**Re: LC 73 – Portland General Electric Company’s Reply Comments**

**Docket LC 73**

2019 Integrated Resource Plan.

**REPLY COMMENTS**

Figure 1. Solar ELCC Comparison<sup>71</sup>

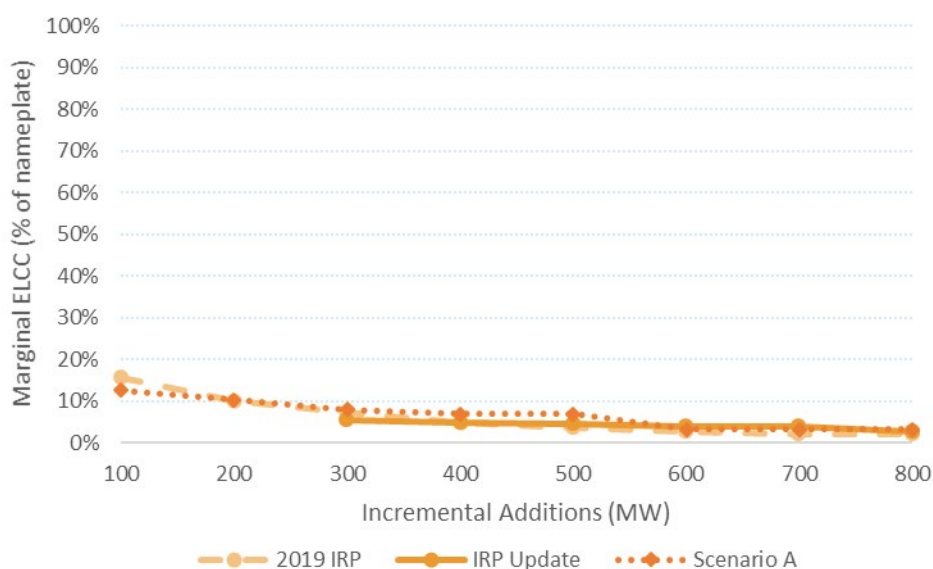
In comments, REC and NewSun questioned the solar ELCC values based on the inclusion of the CSP in the Baseline Portfolio and the inclusion of all executed QF contracts.<sup>62</sup> Their suggested treatment would reduce the quantity of solar resources in the Baseline Portfolio, potentially leading to a higher ELCC value for the first increment of additional solar resources, and consequently, likely lead to higher avoided cost prices for solar QF developers than those based on the IRP Update. PGE disagrees with their comments and responds to them in **Sections 4.3** and **4.4**.

In comments, Staff expressed an interest in better understanding the change to the ELCC value for the first increment of solar resources relative to the 2019 IRP when considering the change to the market capacity assumption.<sup>72</sup> While PGE has not conducted analysis to estimate the market capacity impact on the ELCC study in isolation from the other updates, we note that the market capacity change in 2025 was relatively minor—a decrease to the availability of summer on-peak market capacity of 26 MW. All else held constant, if the market capacity values had remained at the values

In order to provide additional insight into the impact of the increase in solar resources in the Baseline Portfolio, PGE conducted new analysis for a scenario that examined the impact on ELCC values if 200 MW of solar resources were removed from the Baseline Portfolio. **Figure 1** compares the ELCC values for solar from the 2019 IRP, the IRP Update, and the scenario (labeled Scenario A in the figure). The figure aligns the ELCC values based on the approximate quantity of solar resources in each study. Scenario A showed a similar pattern to the 2019 IRP, with a higher initial ELCC value for solar than the IRP Update (as expected due to the reduction of solar in the portfolio compared to the IRP Update), and a declining value for the next increments.

There was little change to the ELCC values for Gorge Wind and the SCCT in Scenario A compared to the IRP Update (26 percent and 95.2 percent in Scenario A compared to 25 percent and 95.5 percent in the IRP Update).

Figure 4. Draft 2022 IRP Overnight Capital Costs from Roundtable 21-1<sup>119</sup>

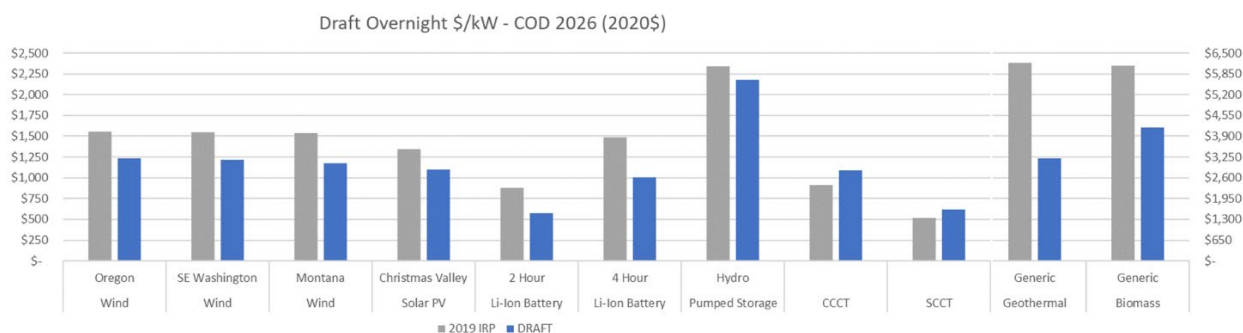
NewSun requested that PGE provide draft Schedule 201 prices and the pricing workbook in the IRP process.<sup>117</sup>

PGE further notes that as shared during Roundtable 21-1 (and included in **Figure 4**), draft resource cost information for the 2022 IRP indicates a material decline of the forecasted overnight capital costs for wind and solar resources compared to the 2019 IRP, with a slight increase to the cost of a simple-cycle combustion turbine. This indicates that even if the inputs from this IRP Update are included in the May 1 price update, PGE customers may continue to pay inflated prices to QF developers for resources PGE could likely procure at lower costs. However, given that the work on these draft resource cost and performance reports have not been finalized, PGE did not include it in this IRP Update.<sup>118</sup>
